Donald C. Cook Nuclear Plant Units 1 and 2  
REVIEW OF PRELIMINARY ACCIDENT SEQUENCE PRECURSOR  
ANALYSIS OF OPERATIONAL CONDITION

## ATTACHMENT 1 TO C1199-15

### LICENSEE REVIEW OF PRELIMINARY ACCIDENT SEQUENCE PRECURSOR ANALYSIS

EVENT TREE

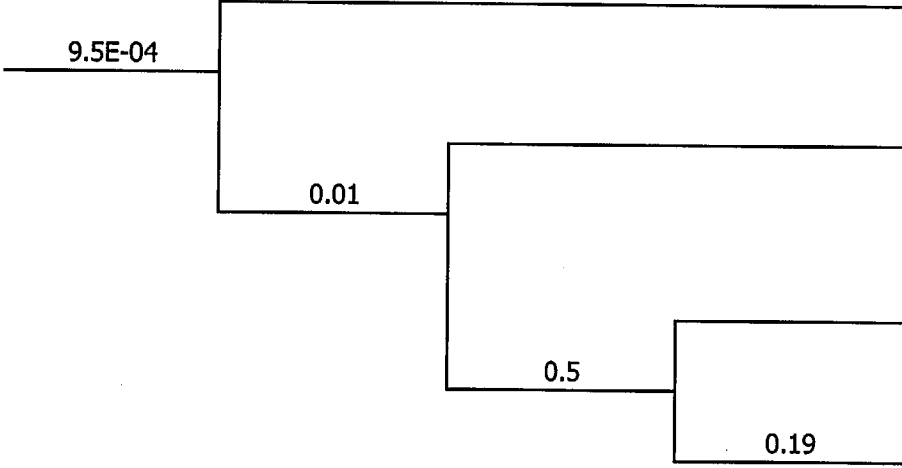
Attachment 2 provides an event tree analysis performed with the alternate modeling assumptions showing the derivation of the change in CDF of  $9.0 \times 10^{-7}$ .

Combining the changes to the two modeling assumptions in the NRC assessment (i.e., an equal probability for the FW and MSL break and that the piping segments that can impact the CCW pumps conservatively represents 1 percent of the HEL) results in a CDF of  $9.0 \times 10^{-7}$ , as presented in Attachment 2.
